SUBJECT: Forwards response to requests 5 through 12 of addl info re
 NUREG-0737 Item II.D.1, "Performance Testing of Relief &
 Safety Valves."

Subject: Oconee Nuclear Station
Docket Nos. 50-269, -270, -287
"Performance Testing of Relief and Safety Valves"
Request for Additional Information

"PERFORMANCE TESTING OF RELIEF AND SAFETY VALVES"
RESPONSE TO REQUEST FOR ADDITIONAL INFORMATION
(5 THROUGH 12)

Figure 1. RELAP5 Model of Pipe with Bend

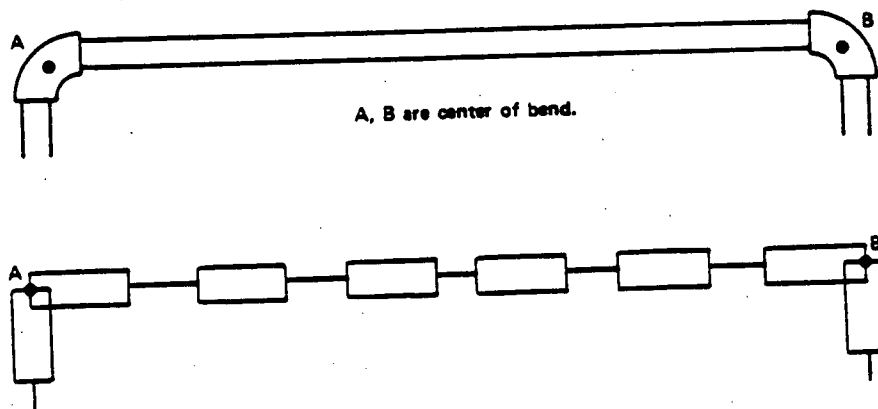
Discuss how REPIPE calculates piping forces from RELAP5 output and provide results of verification calculations for EPRI/CE tests for our review.

In order to conform to the modeling guidance given by the REPIPE code authors, each straight leg of piping was modeled with one or more straight control volumes that extended to the center of the bends at each end. This concept is illustrated in Figure 1. The turning of the fluid is assumed to occur in this mid-bend junction, not within a control volume. The pipe stress model does not have to include a node at the bend midpoint to match this resulting junction. In fact, the associated piping nodes were at either end of the bend where the forces can be input in line with the pipe.

Placing a turn in a junction as shown in Figure 1 presents no physical problem. In fact, the turning loss coefficients are input to RELAP5 at junctions. But equation (5) is applicable to a fluid volume, not a point or area (junction). This purely mathematical restriction is circumvented by assuming a massless "virtual volume" in the junction.
